# TABLE OF CONTENTS AC-21-17 PR-2021-005442 SI-2021-01714\_VA-2021-00412

SUBJECT: AC-21-17, PR-2021-005442, SI-2021-01714: Modrall Sperling Law Firm, agent for Columbus Pacific Properties Ltd., appeals the decision of the Development Review Board (DRB) to approve an EPC Site Plan Final Sign-Off for all or a portion of LOT A-2-A-A, THE PLAZA AT PASEO DEL NORTE zoned MX-M, located on EAGLE RANCH RD between PARADISE BLVD AND IRVING BLVD NW containing approximately 7.12 acre(s). (C-13)

Project# PR-2021-005442
Application#
SI-2021-01714 EPC SITE PLAN FINAL SIGN-OFF

**SDP1.1**

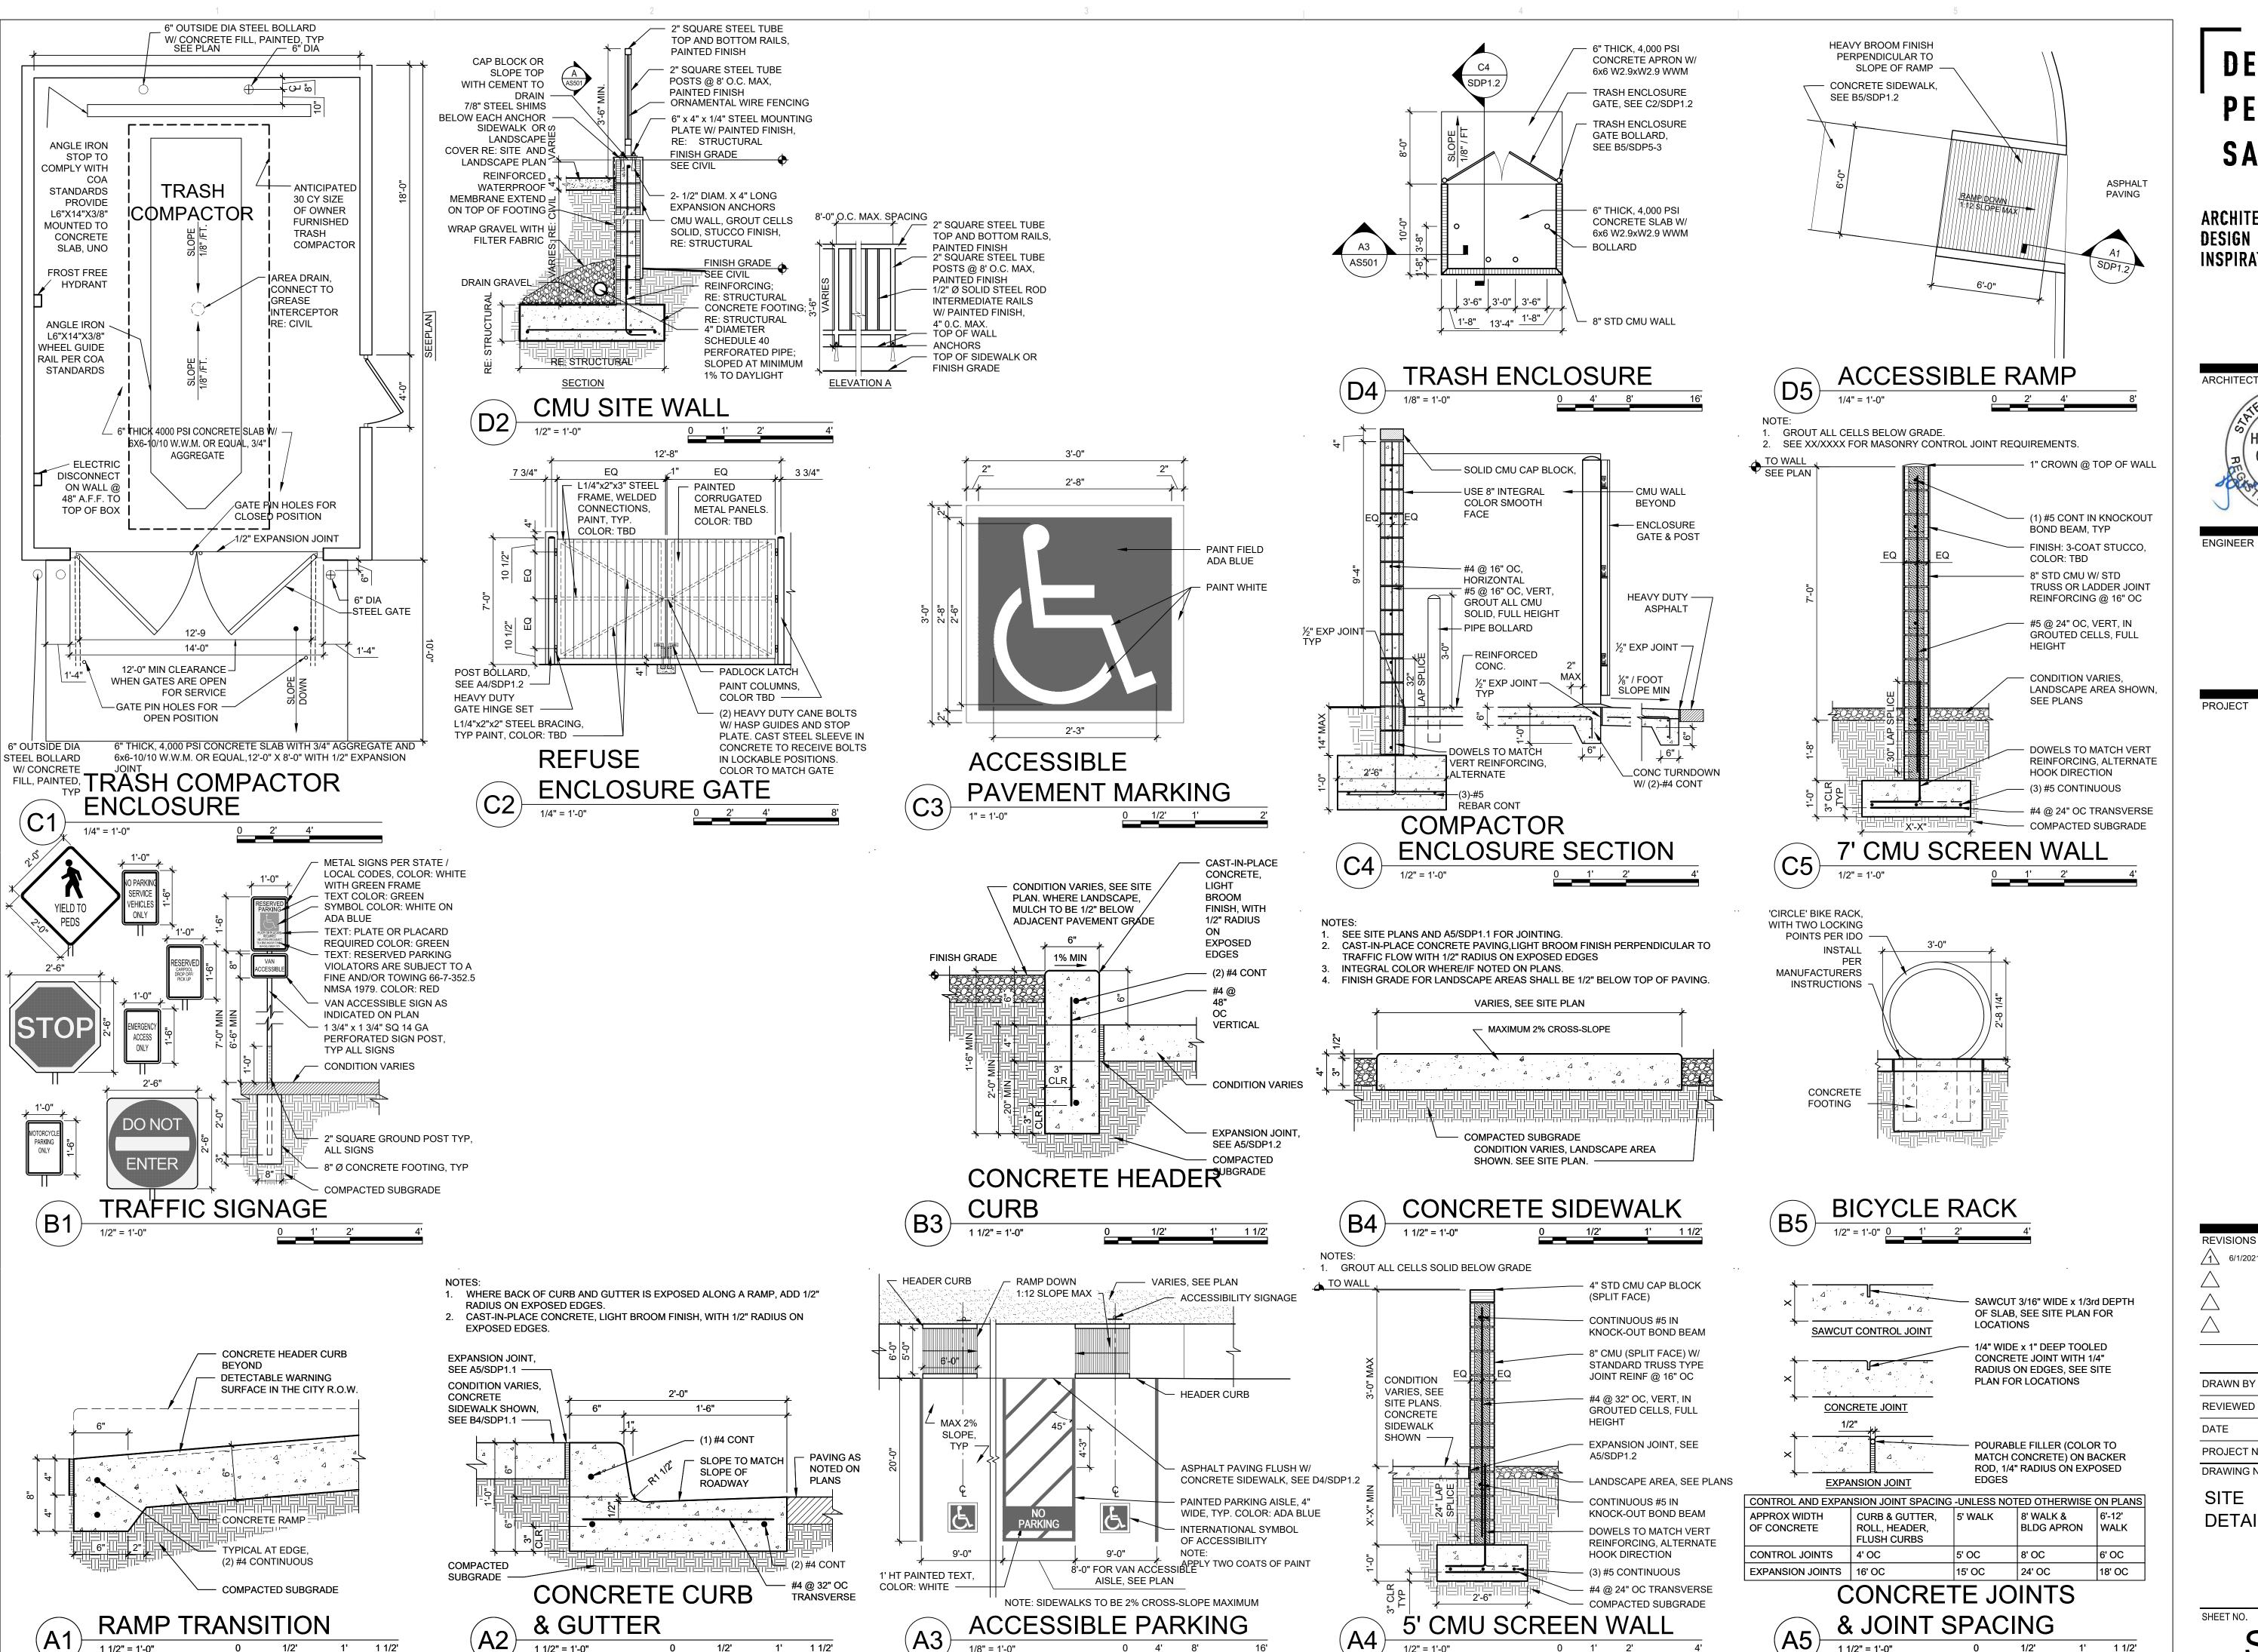
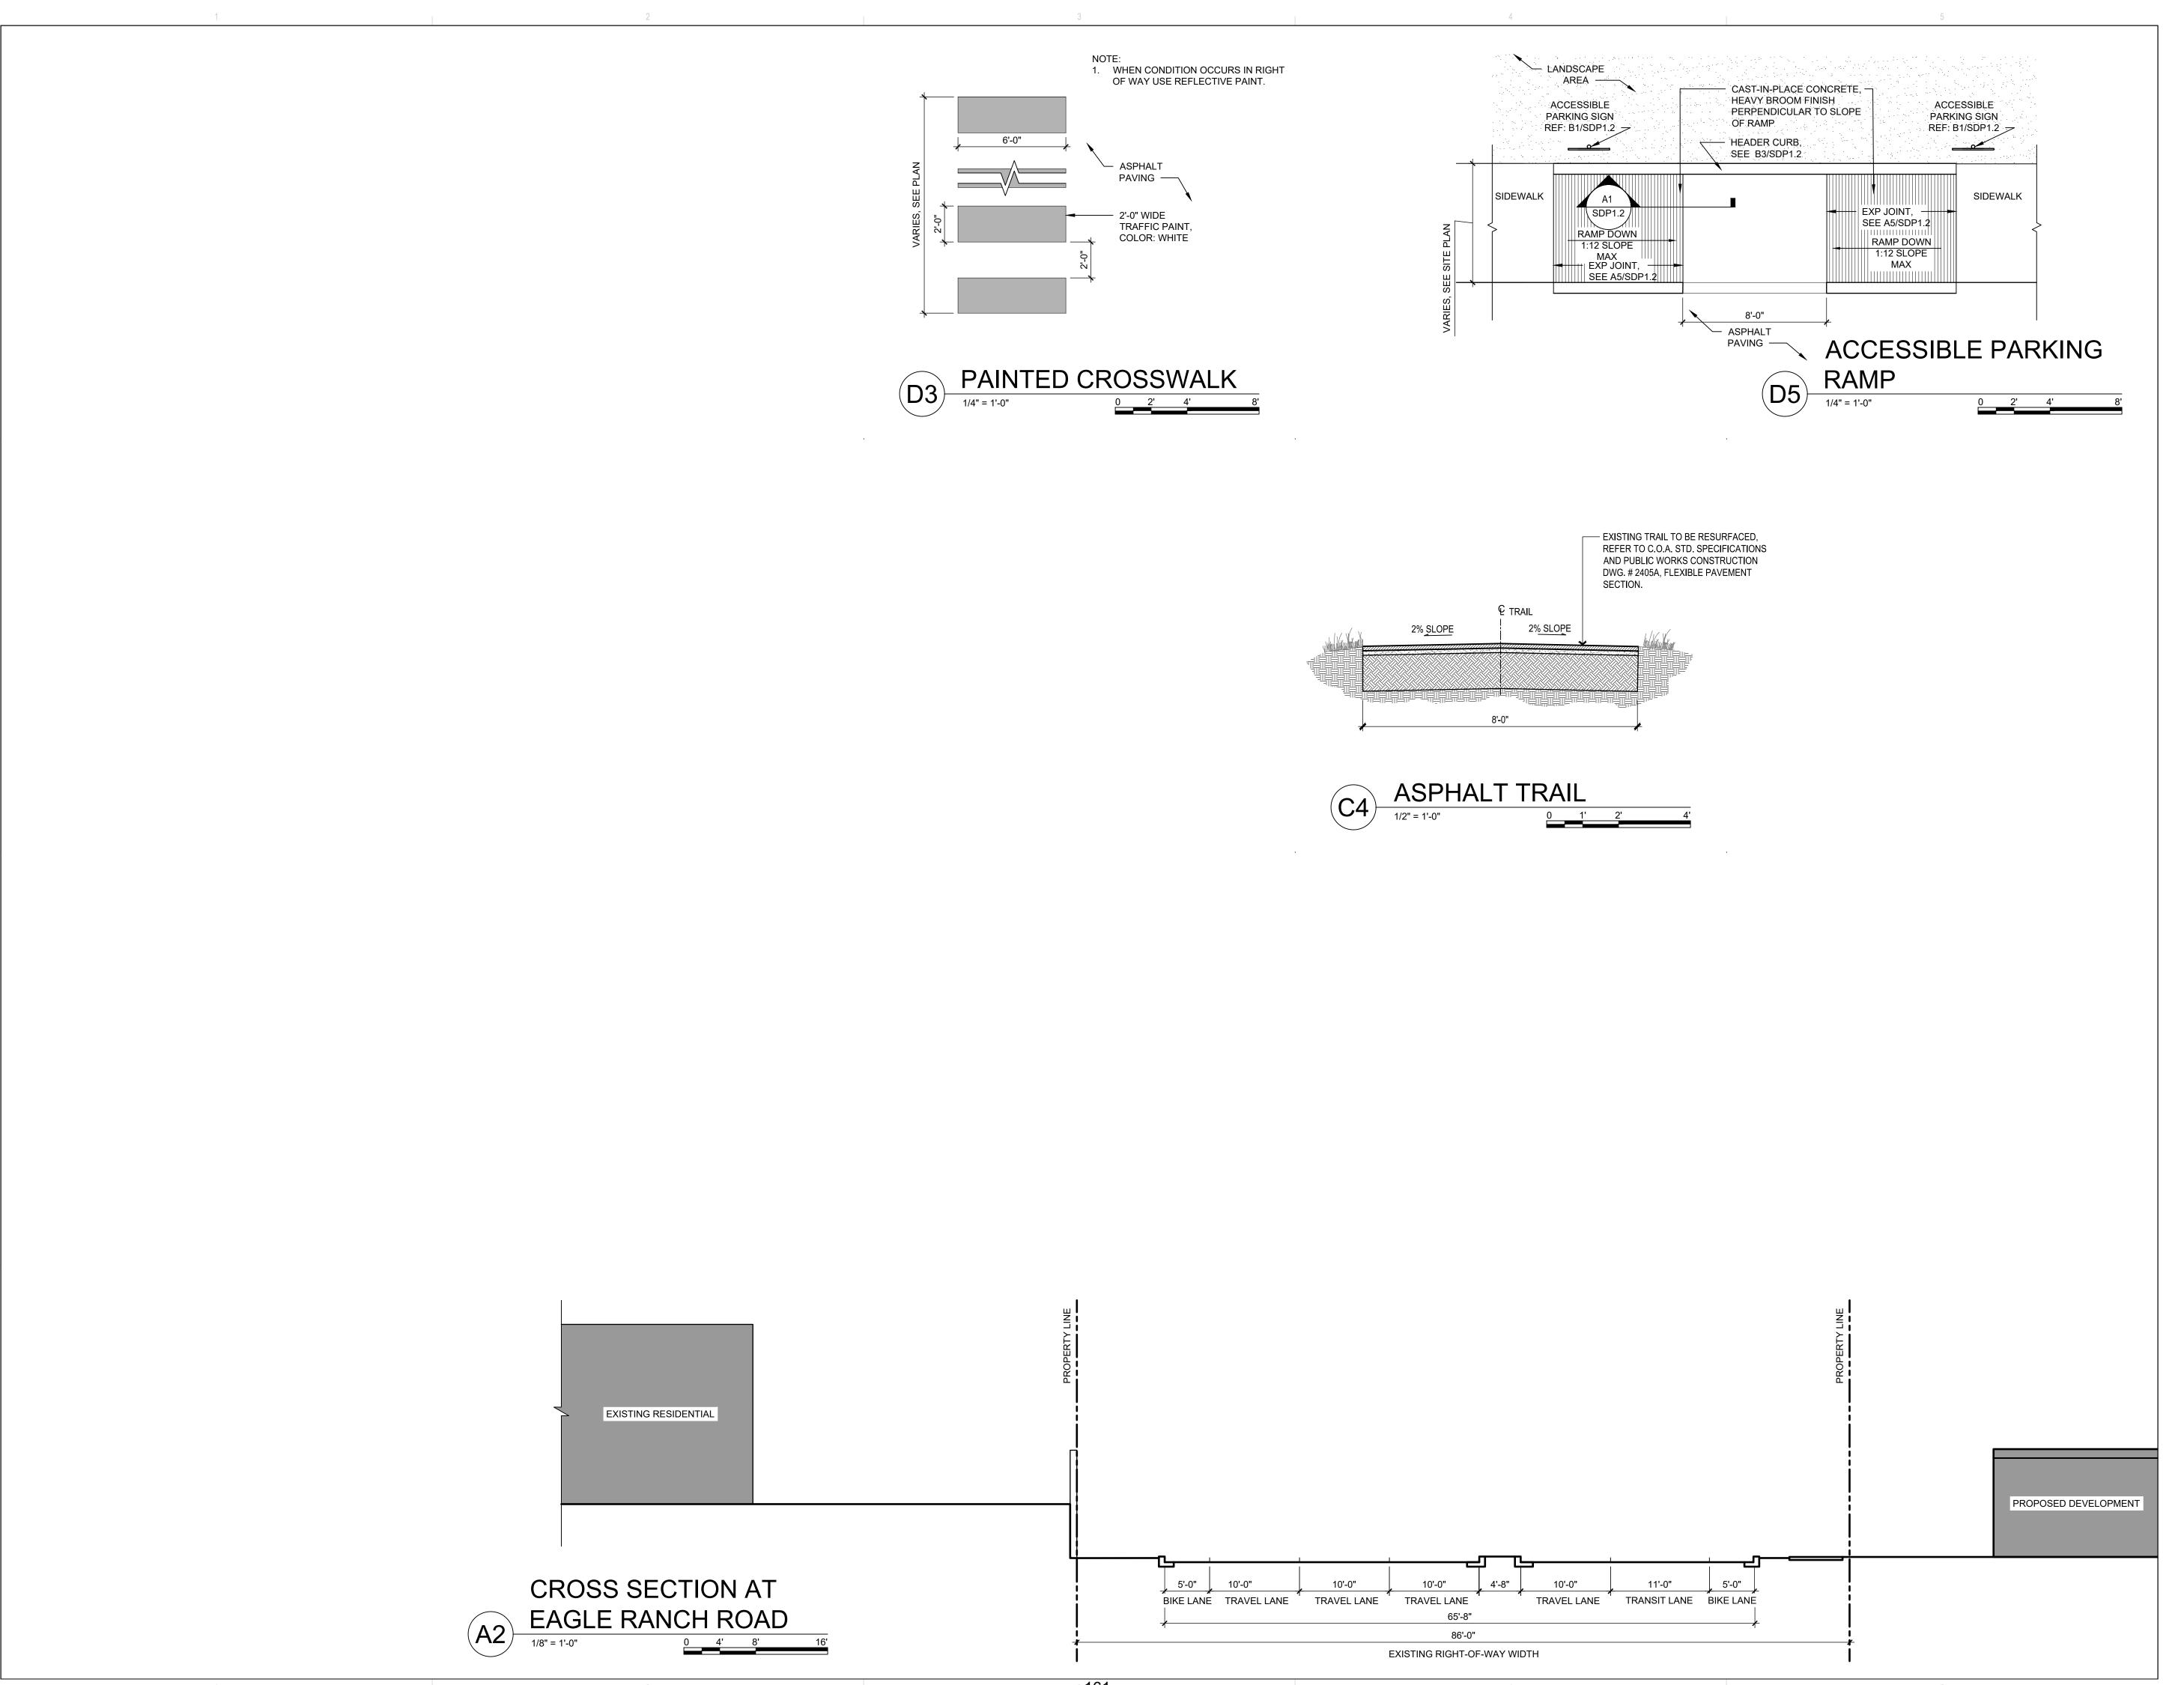
In the notice of decision from EPC, there was a Condition Number 4 for calls and security talking about the -- a requirement to provide detail of the retaining wall. And the response says that it was provided at sheet SDP 1.2, but I didn't see any detail for an actual retaining wall. And also, if that can be indicated exactly where that's located on the site plan, as well.

BUILDING A - WEST ELEVATION(STREET-FACING FACADE)

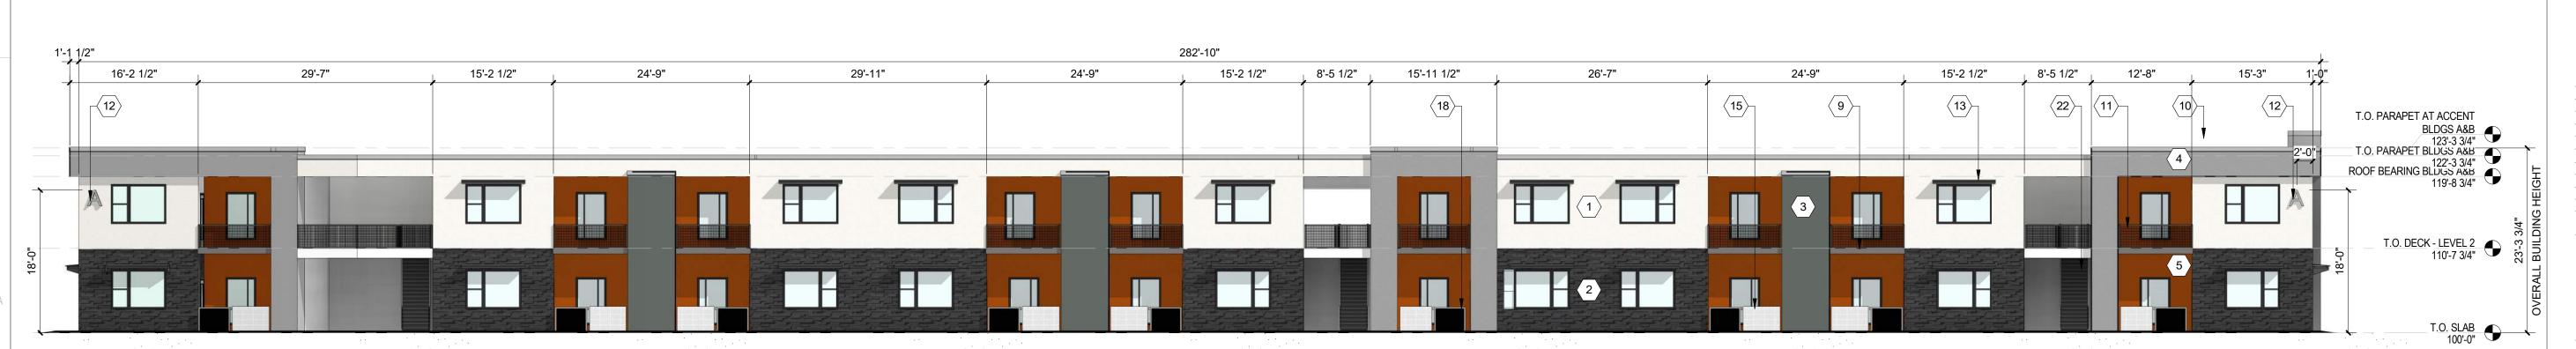
Please indicate which keyed note references the trail as mentioned in the EPC Conditions Response Letter. Is there a detail for the new trail connection to the access drive?
